TECHNICAL BULLETIN

[Issue No.] FA-A-0205

[Title] Announcement for the changes in the packages of the CC-Link/LT Remote I/O Station Communication LSI (CLC21) and CC-Link/LT Remote Device Station Communication LSI (CLC31)

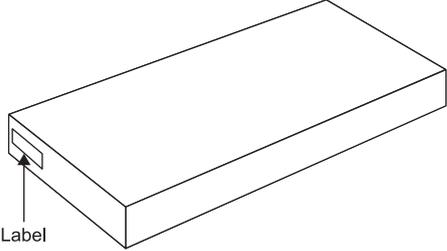
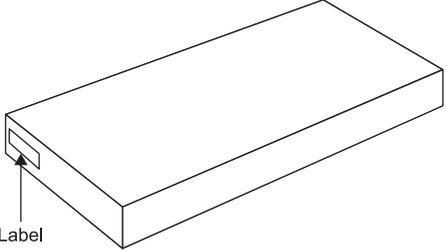
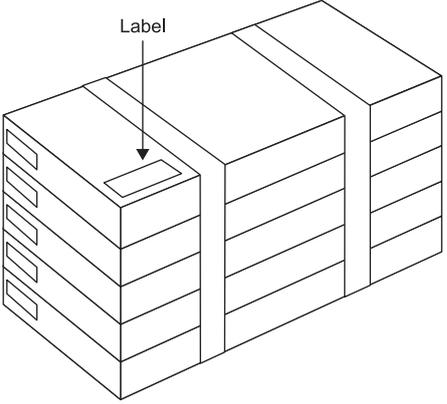
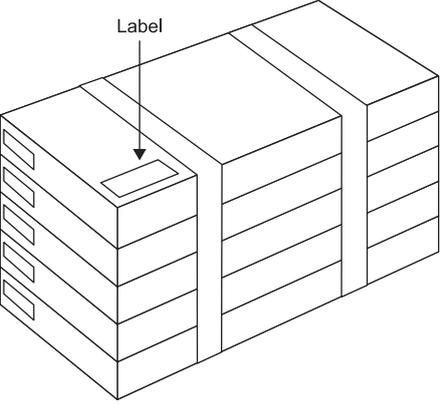
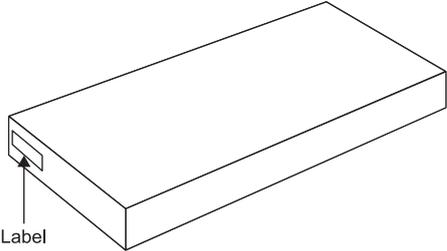
The current package is required to be replaced with the alternative due to the discontinuation of production.

CC-Link/LT Remote I/O Station Communication LSI (CLC21)		
Item	Before change	After change
Prints on package		
Package dimensions (Unit: mm)

CC-Link/LT Remote Device Station Communication LSI (CLC31)		
Item	Before change	After change
Prints on package	<p>The lead-free/RoHS directive compliant identification dot mark</p> <p>CLC31 PC02004N-A</p> <p>Lot No.</p>	<p>CLC31 PC02004N-A</p> <p>Lot No.</p> <p>The lead-free/RoHS directive compliant identification dot mark</p>
Package dimensions (Unit: mm)	<p>1.00 ±0.20</p> <p>0.145 ±0.05</p> <p>0.50 ±0.20</p> <p>1.0</p> <p>1.1 ±0.1</p> <p>0.25</p> <p>3° ^{+4°}/_{-3°}</p> <p>0.5</p> <p>0.6 ±0.15</p> <p>0.1 ±0.05</p>	<p>1.00 ±0.20</p> <p>0.145 ±0.05</p> <p>0.50 ±0.20</p> <p>1.4 ±0.05</p> <p>1.60MAX</p> <p>0.1 ±0.05</p> <p>0.25</p> <p>3° ^{+5°}/_{-3°}</p> <p>0.5</p> <p>0.6 ±0.15</p>

(1) Only the package and the prints of the communication LSI have been changed. The specifications, functions, and solderability are not changed.
